Administrative Action Administrative Site Review

Case File / Name: SR-8-14 / Boulevard Park Subdivision, Lot 1-A

Request: Redevelopment of a .38 acre tract, zoned Residential-10 and Special Residential Parking Overlay, into an attached house. The proposed building square footage is 4,328 square feet gross. The attached house proposes four bedrooms per dwelling or eight bedrooms total. Parking will be provided by onsite parking, consisting of 8 parking spaces. The proposed parking does exceed the required parking in excess of one hundred and fifty percent however as a two-unit living use, or a use providing ten or fewer surface parking spaces, it is exempt from the maximum surface parking requirements of 7.1.2 D of the UDO.

Site Plan

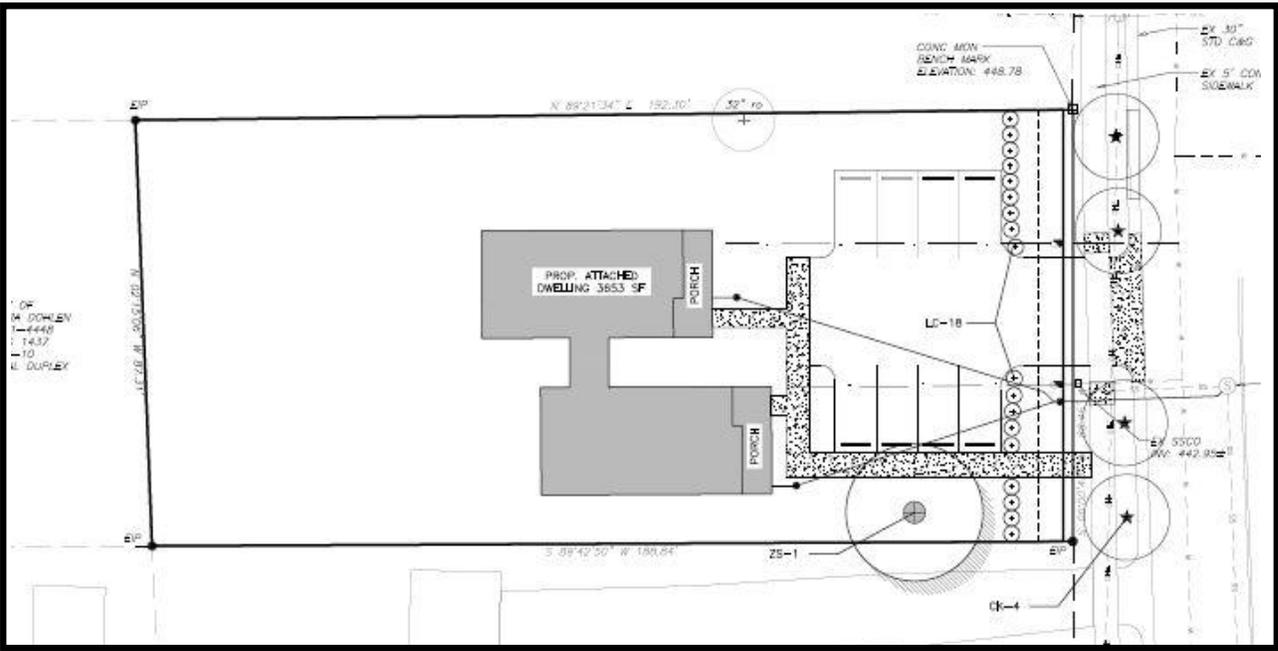
The block perimeter for the proposed property does not meet the minimum standard of 2,500' based on the average lot size within the subdivision and the zoning district. A Design Adjustment waiving the block perimeter requirement of Section 8.3.2.A.2.b per Section 8.3.2.B.6 has been granted by the Public Works Director.

A 5' sidewalk exists along the property. A fee-in-lieu for 1' of sidewalk will be required to meet the 6' standard per the UDO.

In order to meet the required ROW width for ½ - 64' ROW for an Avenue 2-Lane undivided street, an additional 2' of right of way is being dedicated.

The Residential Streetscape of an existing street for the proposed site does not meet the minimum 6' planting area, or the minimum 2' maintenance strip within the Right of this street type. A Design Adjustment waiving both the 2' of the required minimum 6' of planting area, and the 2' minimum maintenance strip as required by 8.5.2 D of the UDO has been requested from the Director of Public Works.

As per 2.2.7 B, this plan is compatible to Residential Infill. The location of the building complies with the setback established within the range of the two closest lots in either direction as per 2.2.7 C. The maximum allowed wall height adjacent to the side property line is 22' as per 2.2.7 D. The wall height of the proposed attached house is 20'-2" as per plan. Side Wall articulation is not required as the side walls are less than 22' tall. No wall recession is required as the length of the wall is less than fifty feet as per 2.2.7 E. The residential building type complies with the guidelines of the UDO.

1. That a demolition permit, if applicable, be issued and this building permit number be shown on all maps for recording;

2. That a fee-in-lieu for 1 additional foot of sidewalk be paid to comply with the UDO standard of a 6' sidewalk;
3. That 1/2 - 64' of the required right of way for an Avenue 2-Lane undivided Road (Method Road) is dedicated to the City of Raleigh and a copy of the recorded plat be provided to the City prior to building permit
4. That driveway permit are issued for the driveway;

5. That a right of way permit is obtained from the urban forester in the Parks and Recreation Department for landscaping in the public right-of-way;
